Minutes of Local Traffic Committee Meeting Held at Petersham Service Centre on 3 February 2020

Letter to Inner West Local Traffic Committee | DA201900096 - 182-198 Victoria Road and 28-30 Faversham Street, Marrickville | 3 February 2020

Figure 1 GoGet Car Share Pod located on corner of Sydenham and Victoria Roads (Approx. 105 metres from site)

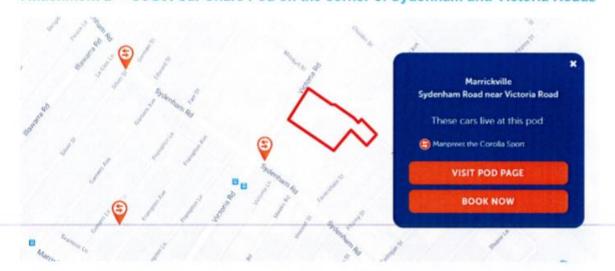
Attachment B - GoGet Car Share Pod on the corner of Sydenham and Victoria Roads
